CITY OF BLOOMINGTON

PLAN COMMISSION

September 11, 2017 @ 5:30 p.m.
COUNCIL CHAMBERS #115
CITY HALL

**BLOOMINGTON PLAN COMMISSION
STAFF REPORT**

GROUND FLOOR SITE PLAN

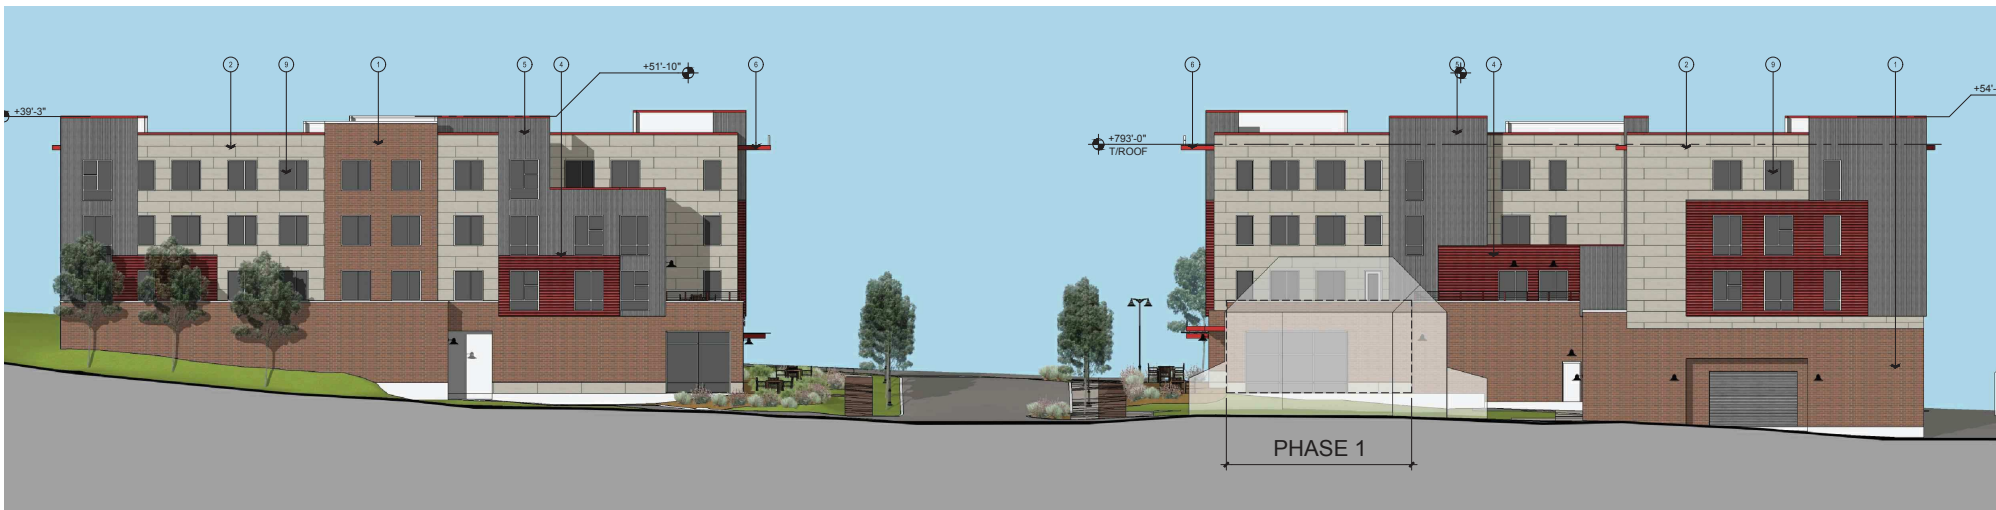
Each building contains retail space, parking, a bike room, and a trash and recycle room. The east building contains 4,834 square feet of retail space, 32% of the first floor. The retail along Grant Street has been inset to provide outdoor seating areas, similar to properties along Restaurant Row. With steep grades on site, the recessed storefront also allows the patio to be separated from the sidewalk without seat walls or structures in the right-of-way. Addressing concerns of the Department and the Plan Commission, the southwest corner of the building has been redesigned with windows that wrap along the corner.

The west building contains 3,436 square feet of retail space, 37% of the first floor. The northeast corner of the building has been recessed to align with the front façade of the existing historic structure to the north. The petitioner is intending for the historic structure to be used as commercial space in the future. No plans have been submitted at this time.
